FINAL REPORT

**COMPREHENSIVE GROUND-WATER
MONITORING EVALUATION**

**U.S. DEPARTMENT OF ENERGY
FEED MATERIALS PRODUCTION CENTER
FERNALD, OHIO**

**FIGURE 8**

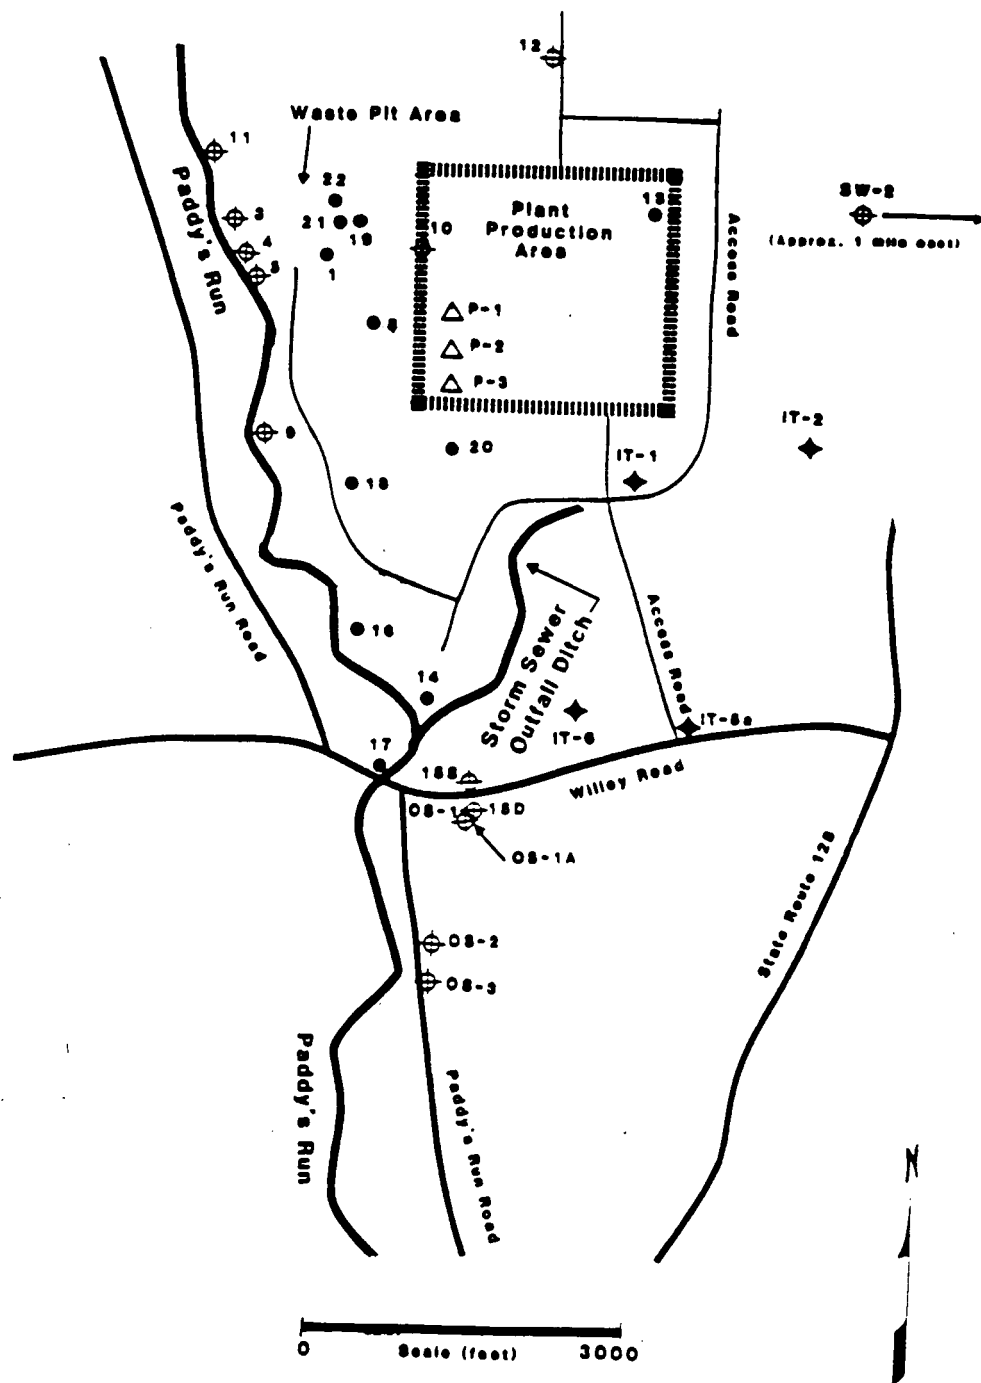
The rationale for the number and locations of wells is not described in the RCRA Sampling and Analysis Plan (DOE, 1987b). As shown on Figure 8, wells at locations 1, 21, 19, and 22 are the only wells close enough to immediately detect a release from Waste Pit No. 4. In addition, the purpose of the other wells, which can be affected by other sources of contamination, is not explained. The location of the detection monitoring wells was adequate, however, to immediately detect a release from the regulated unit because RCRA hazardous constituents and radionuclide contamination was detected in each of the first six sampling rounds. After the contamination was detected, DOE continued to collect the initial background samples on a quarterly basis before conducting a statistical comparison (as required by 40 CFR 265 Subpart F). DOE conducted the statistical comparison after the first semiannual sampling event (round 5), to confirm that statistically significant changes in ground-water quality occurred and that Waste Pit No. 4 may be affecting the ground water (DOE, 1987c).

FIGURE 9

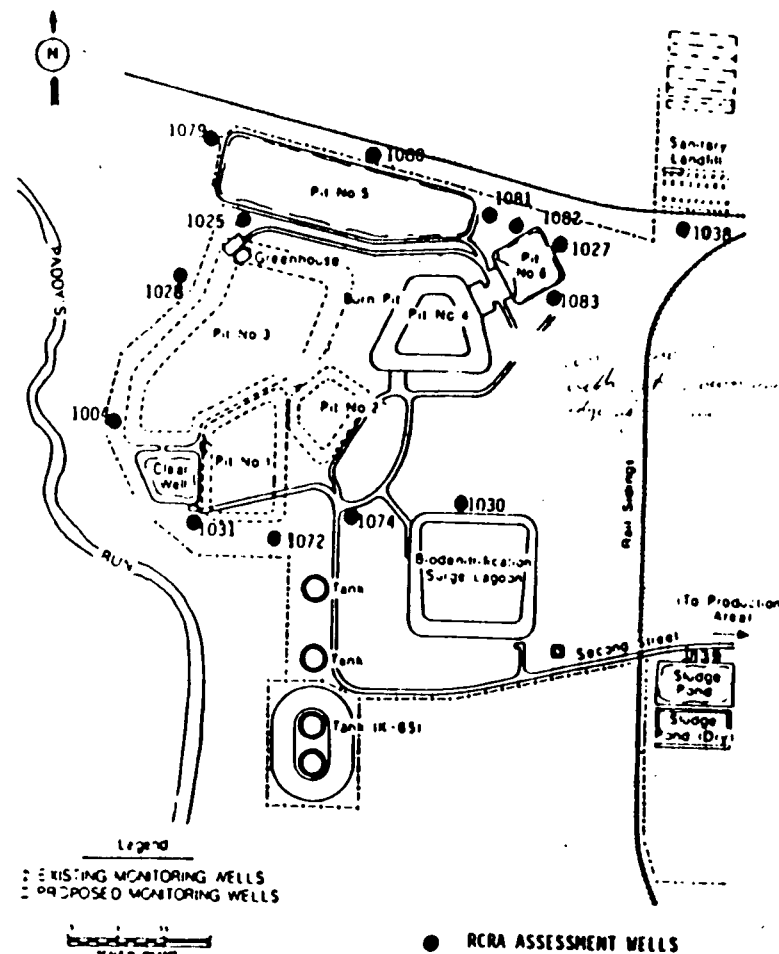
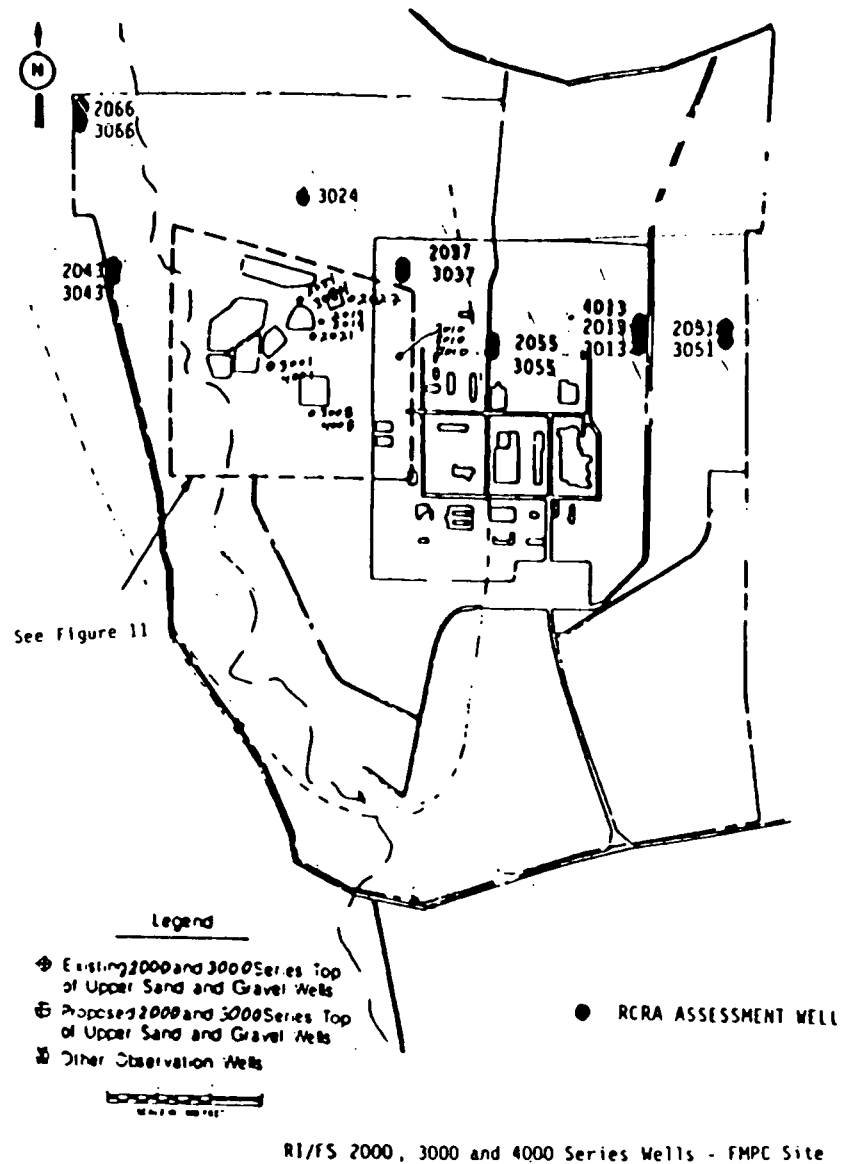
The revised GWQAPP states that 43 monitoring wells will be used in the assessment program. These wells are listed in Table 3 and shown on Figure 9. As shown on Figure 9, the till aquifer is being monitored by 14 downgradient wells and two upgradient wells. The downgradient wells monitor the circumference of the waste pit area. Although not shown in Figure 9, there are a number of wells inside and outside the waste pit area not being used in the assessment monitoring program.

The rationale DOE gives for locating the till aquifer wells at the perimeter of the waste pit area is that several of the waste pits have similar materials in them and that no indicator constituent unique to Waste Pit No. 4 could be identified from the CIS characterization (DOE, 1989a). In addition, DOE stated that it has not made a determination if RCRA hazardous constituents have been released from Waste Pit No. 4; and therefore, it is conducting quarterly monitoring of wells completed in the till unit located around the parameter of the waste pit area (DOE, 1989g). This plan is not adequate because; (1) the wells are too distant from Waste Pit No. 4 to determine if it is releasing RCRA hazardous constituents into the ground water (which well 19TP has already detected, but not included in the present assessment monitoring network), and (2) DOE, in its first 2 assessment sampling rounds did not analyze ground water samples for VOCs, a major class of RCRA hazardous constituents.
